<p>نگهداشت و افزایش تولید میدان نفتی بینک سطح الارض</p> <p>احداث ردیف تراکم گاز در ایستگاه جمع آوری بینک</p>																									
<p>شماره پیمان: ۰۵۳ - ۰۷۳ - ۹۱۸۴</p>

<table><tr> <th colspan="8">HAZOP REPORT FOR COMPRESSOR STATION</th> </tr><tr> <td>D00</td> <td>0004</td> <td>RT</td> <td>GE</td> <td>120</td> <td>PEDCO</td> <td>GCS</td> <td>BK</td> </tr></table>

The purpose of this document is to provide the results of “HAZOP Study” for **Binak Oilfield Development – Surface Facilities; New Gas Compressor Station**.

P-2206 A (NOTE 2)
FIRE WATER DIESEL PUMP
RATED CAPACITY : 5.5 m³/hr
DIFFERENTIAL PRESS. : 2 bar

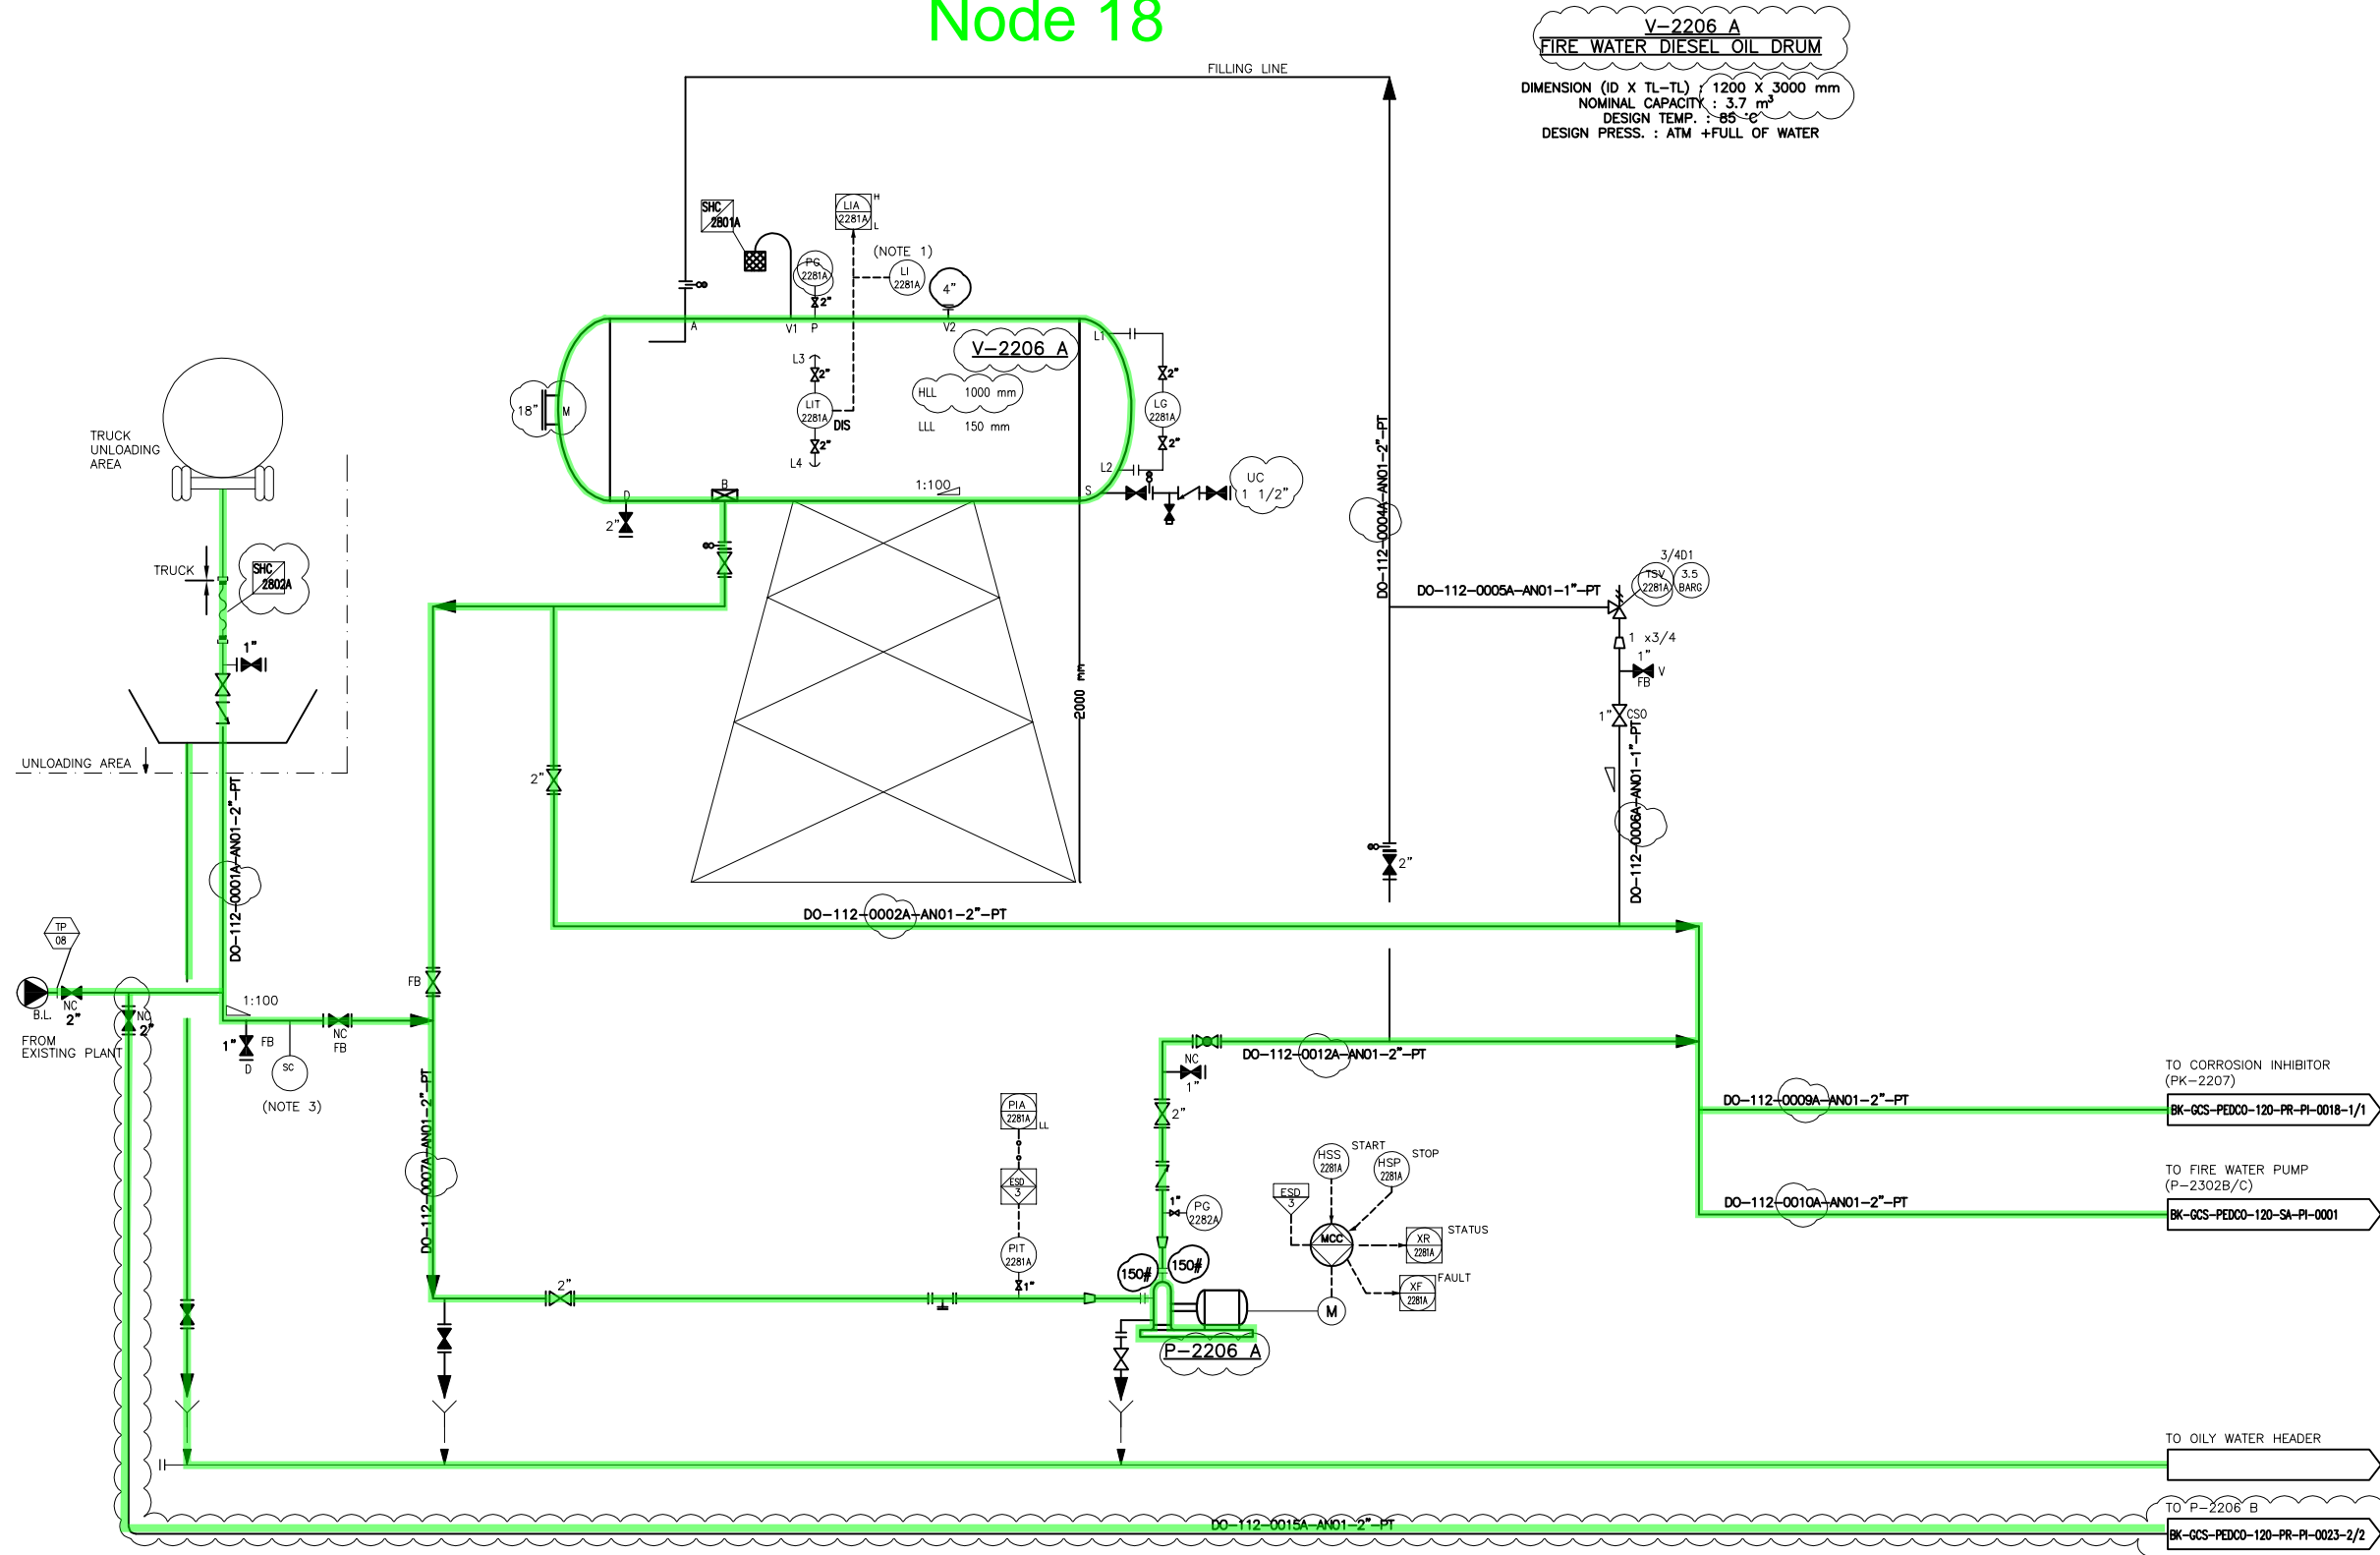
112. Remove fuel gas lines used for blanketing of TK-2102 and V-2107.	Consequences: 17.10.1.1	Contractor	Closed
113. Remove PT-2281A/B from suction of P-2206A/B and consider local pressure gauge.	Consequences: 18.1.3.1	Contractor	Closed

Recommendations	Place(s) Used	Responsibility	Status
should be directed to oily water header.			
116. Remove steam out connection for V-2206A/B.	Consequences: 18.8.1.1	Contractor	Closed

TK-2209
POTABLE WATER TANK

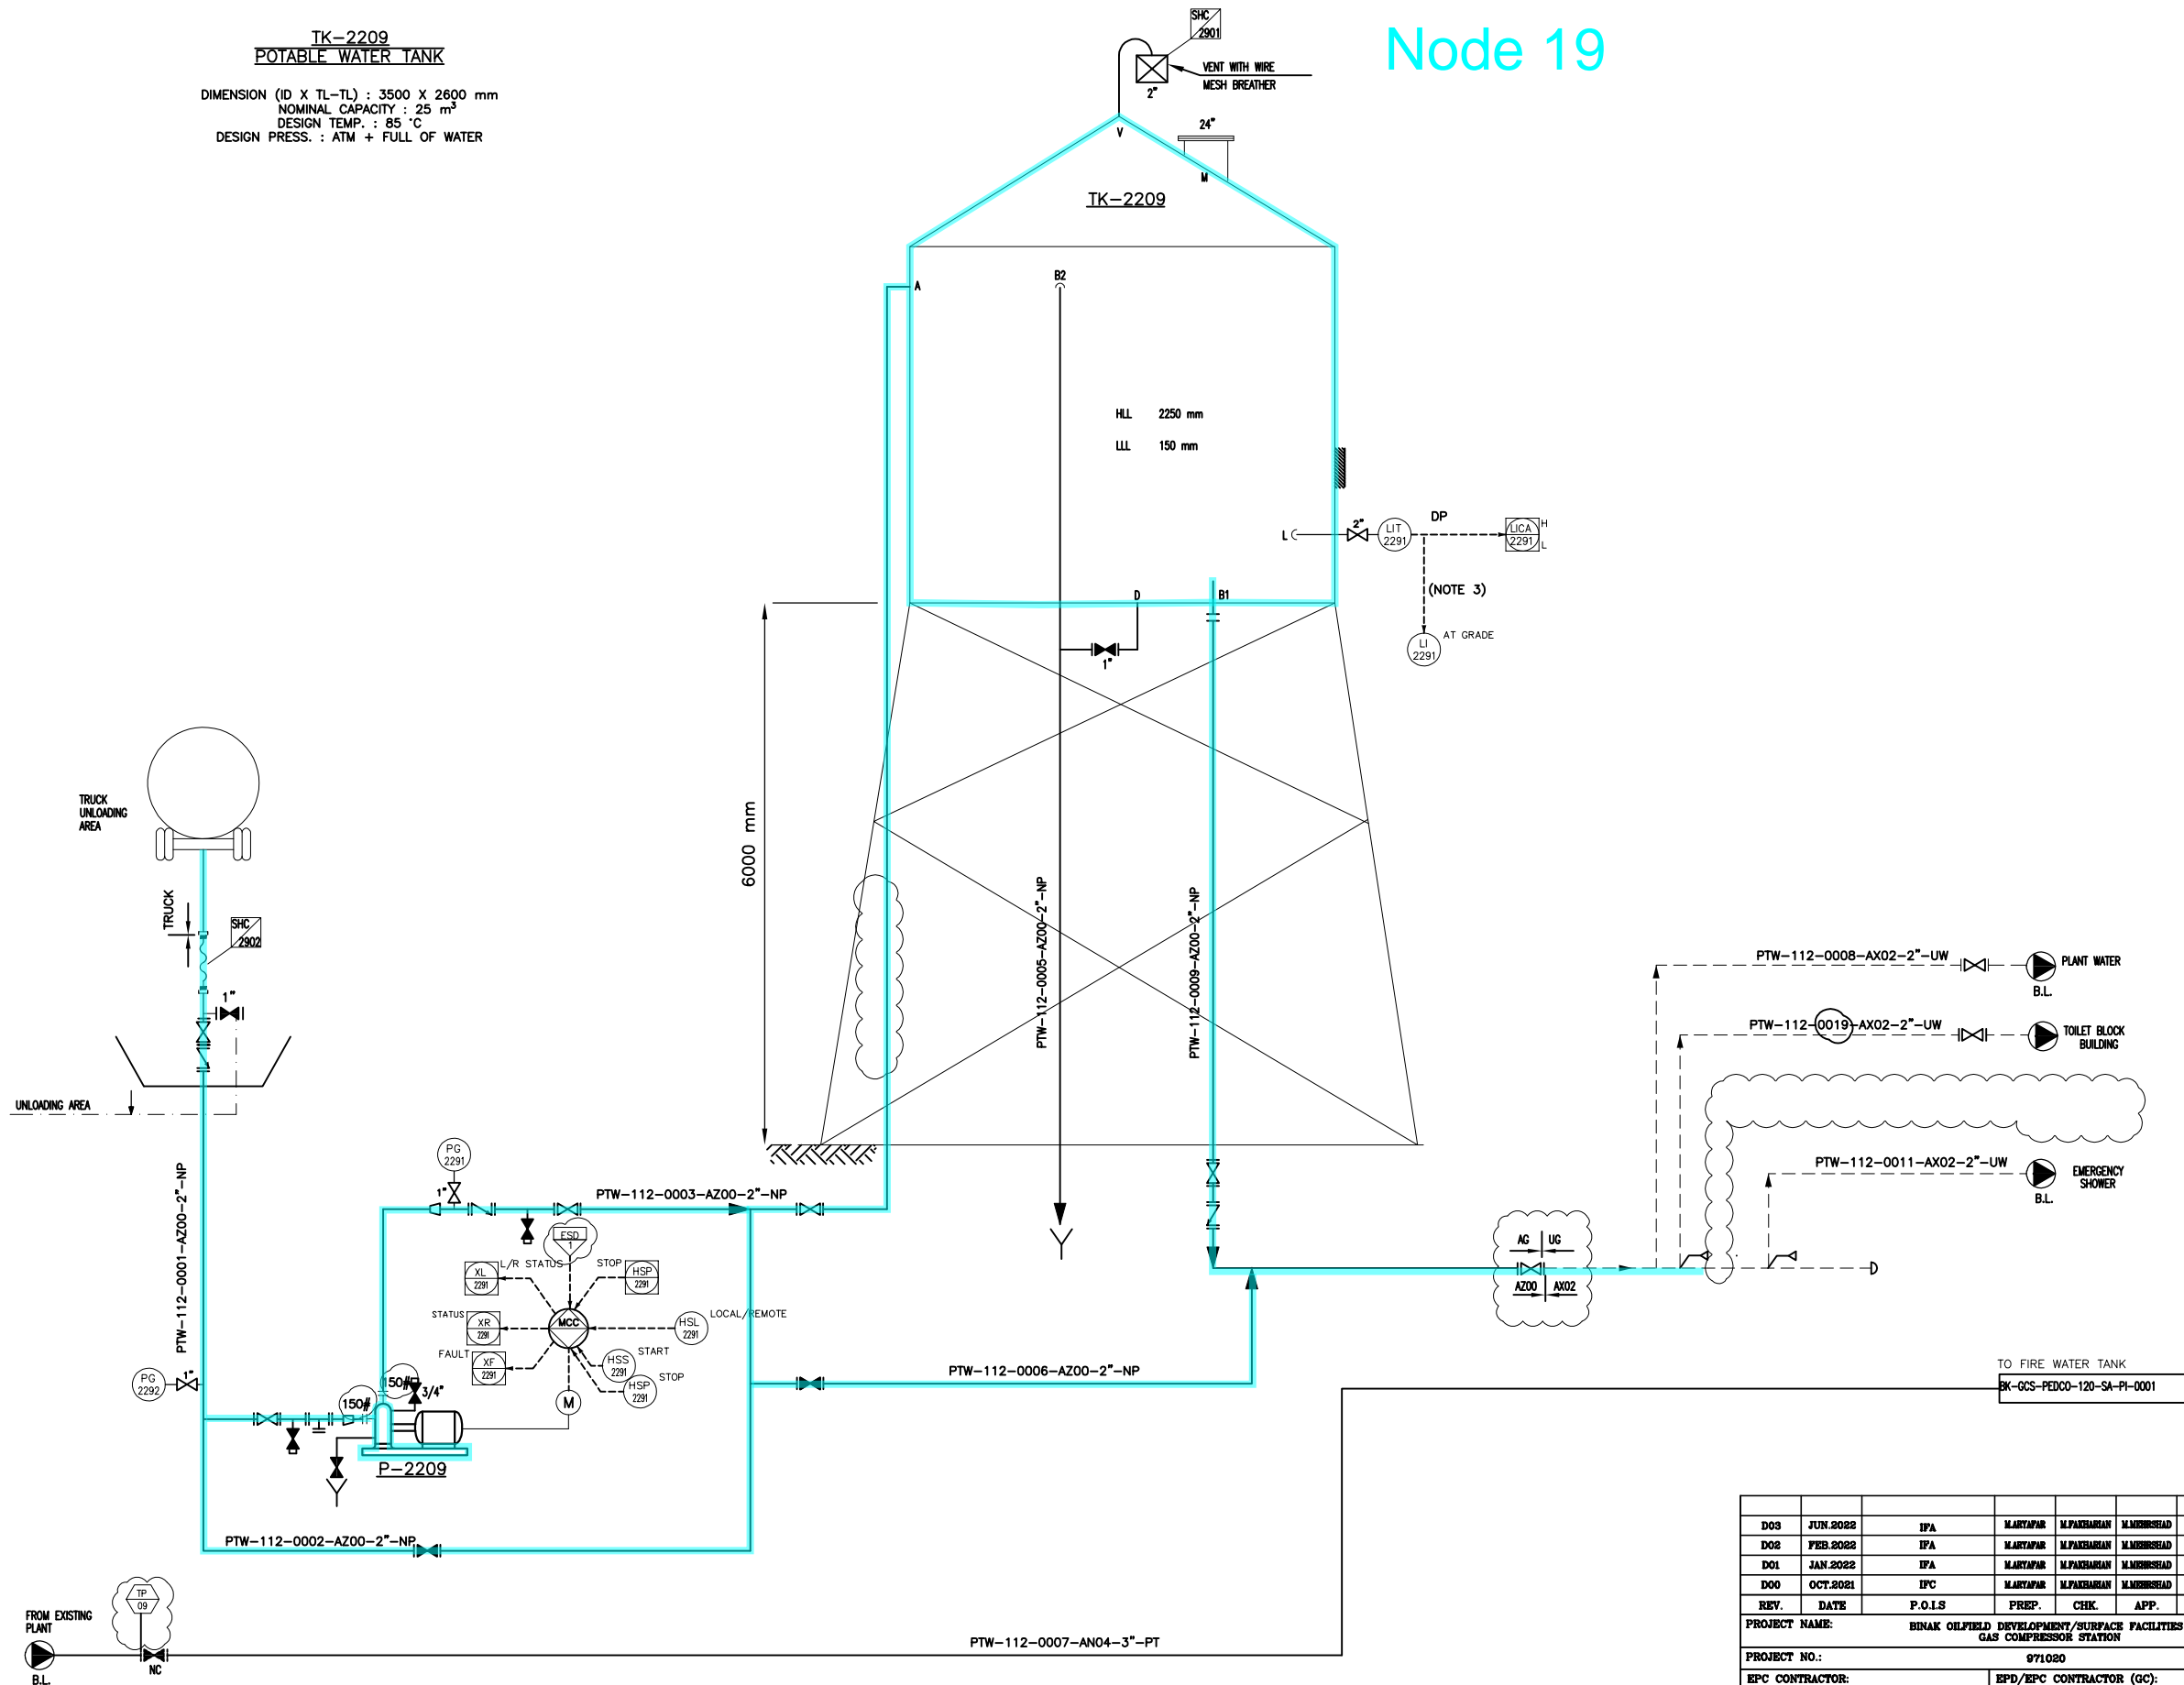
119. Remove ESD-1 signal from P-2209.	Consequences: 19.1.1.1	Contractor	Closed
120. Remove start signal from LT-2293 on P-2104.	Consequences: 20.1.1.1	Contractor	Closed
